MEMORANDUM

To: Planning Commission
From: Community Development Department
Subject: Larson Webster Subdivision No. 2
Amending Lot 2, Larson Webster Subdivision No. 1
3351 East 9980 South
[Community #29 – The Dell]

SUB-05-19-5649
R-1-40 Zone
SAO Overlay Zone

Project Name: Larson Webster Subdivision No. 2

LARSON WEBSTER
SUBDIVISION NO. 2
(AMENDING LOT 2 OF LARSON WEBSTER SUBDIVISION NO. 1)
A PART OF THE SE1/4 OF SECTION 11, T3S. R1E. S11&M.
SANDY, UTAH

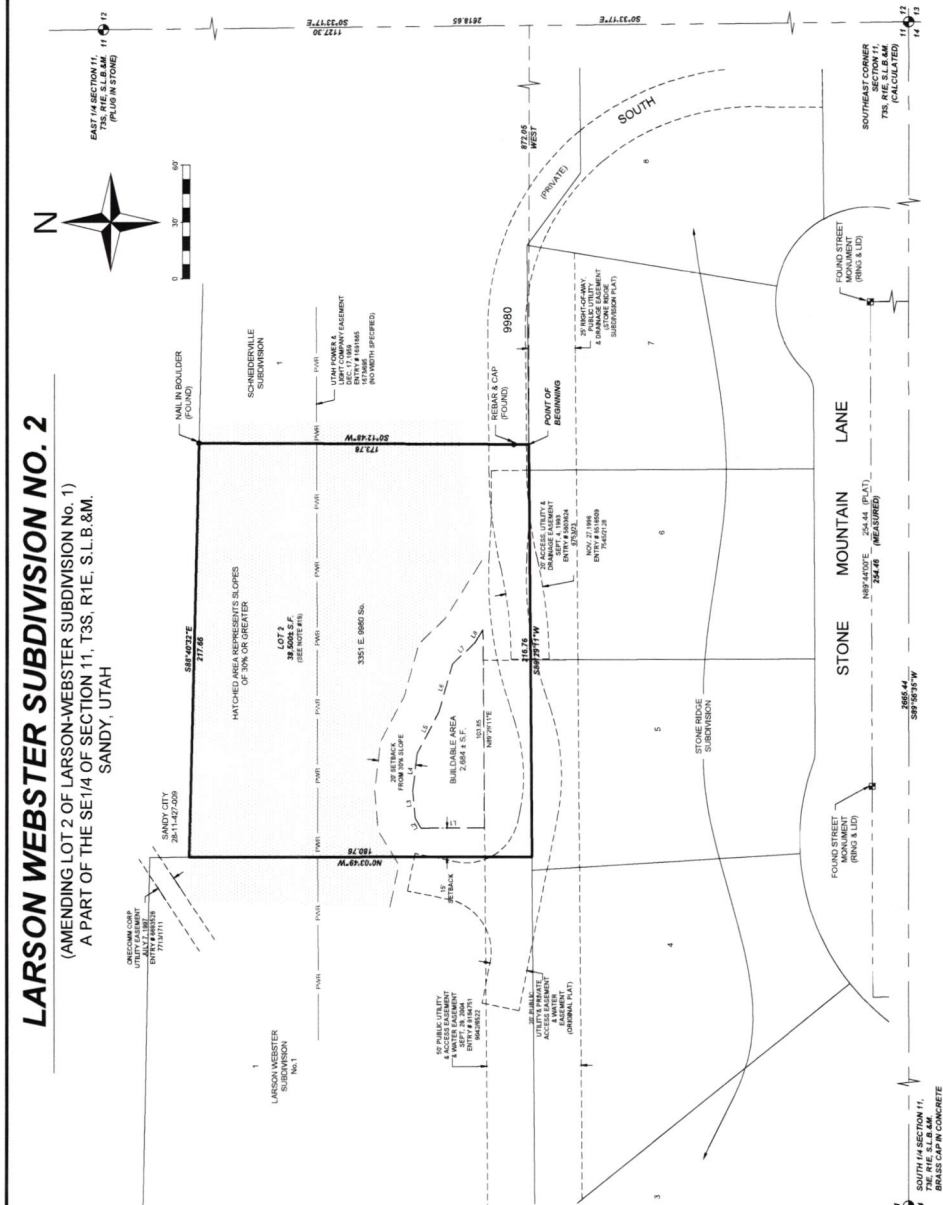
Another issue that has surfaced with this new survey is that the lot boundaries are actually smaller than what was shown on the existing plat. The previous plat created an overlap with the property to the north. This adjustment to the agreed upon boundary line reduces the lot area to below the minimum allowed within the zone. Because this lot has been approved as a buildable lot with the previous plat, Staff would support approving this proposed plat and associated lot as a legal, non-conforming lot to the existing zone.

Staff recommends that the Planning Commission determine that preliminary subdivision review and Sensitive Area Overlay Zone review is complete for the proposed amended plat, Larson Webster Subdivision No. 2, located at 3351 East 9980 South, and be subject to the following conditions:

1. That compliance be made with the Sandy City Water Policy, e.g., water line extensions, connections, water rights, and fire protection.
2. That the property comply with all requirements of the R-1-40 zone, Wildland Urban Interface Zone, and Sensitive Area Overlay Zone. That this amended plat be approved with a legal non-conforming approval disclosed on the plat in relation to the minimum lot size due to the previous plat boundary error of the Larson Webster Subdivision No. 1.

5. That any area equal to or in excess of a 30% slope be indicated (cross-hatched) on the final plat, and that perspective builders and homeowners be apprised of the restrictive nature of the hillside lots.

LARSON WEBSTER SUBDIVISION No. 2
CONTOUR EXHIBIT AND SLOPE COMPARISON
FOR REFERENCE ONLY

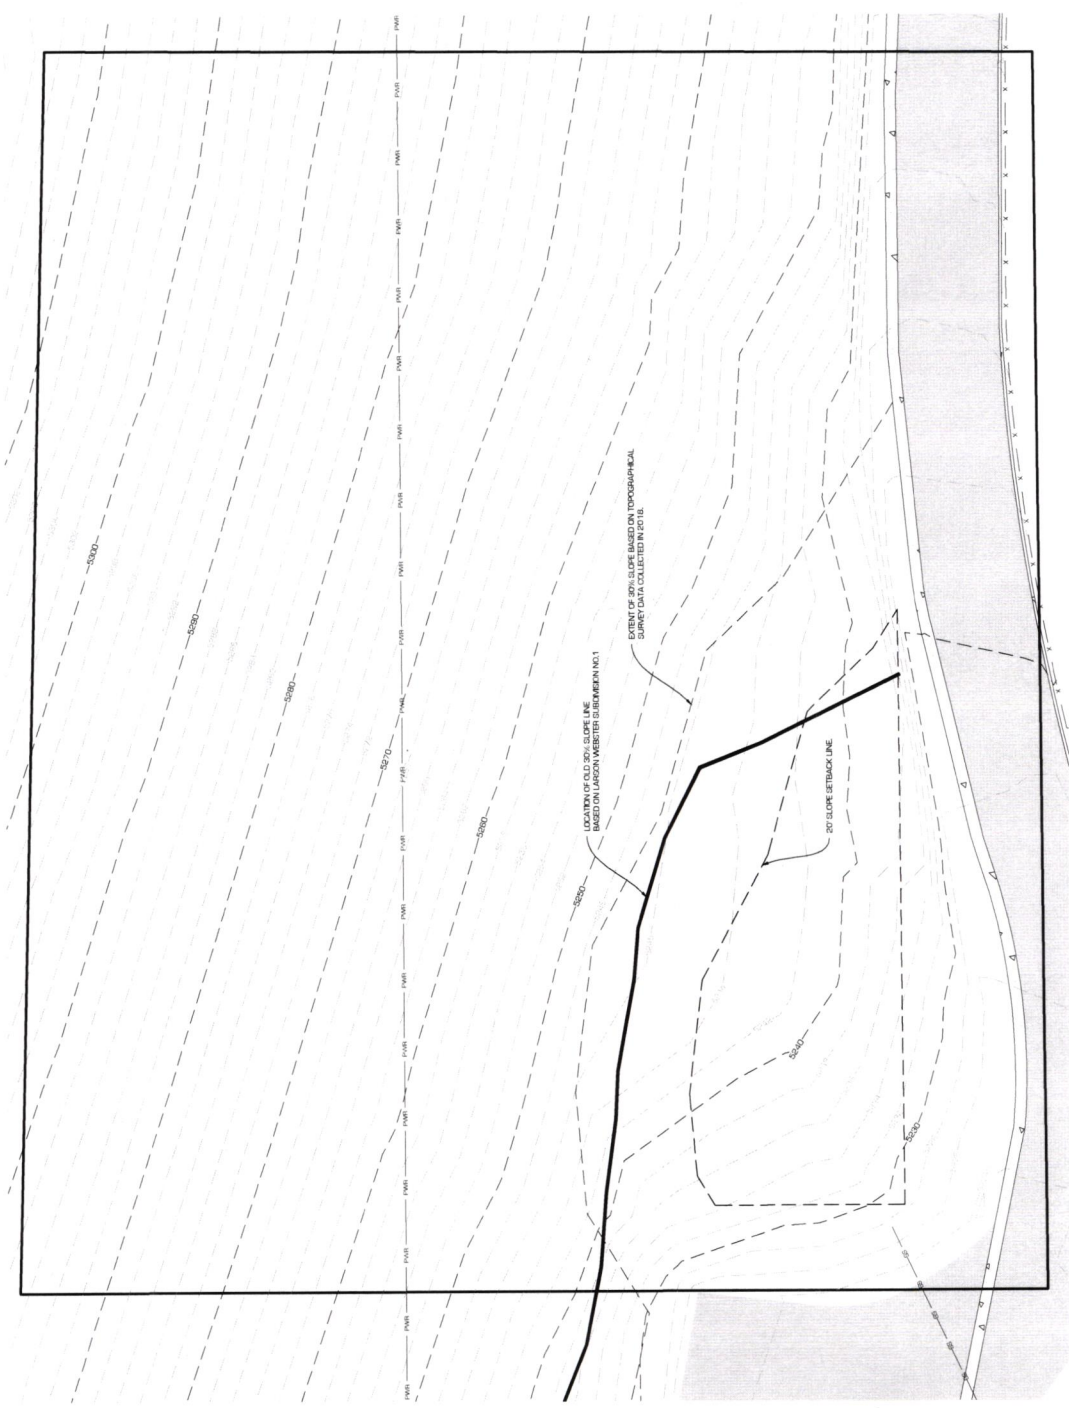
Mr. Utrera has presented new information and evidence through a land survey that shows some discrepancies with the previously recorded plat and the natural contours of the lot. They do not match the 30% unbuildable slope areas that was recorded (see attached comparative survey exhibit). The survey reveals that the buildable area of the lot is larger than what is shown on the plat.
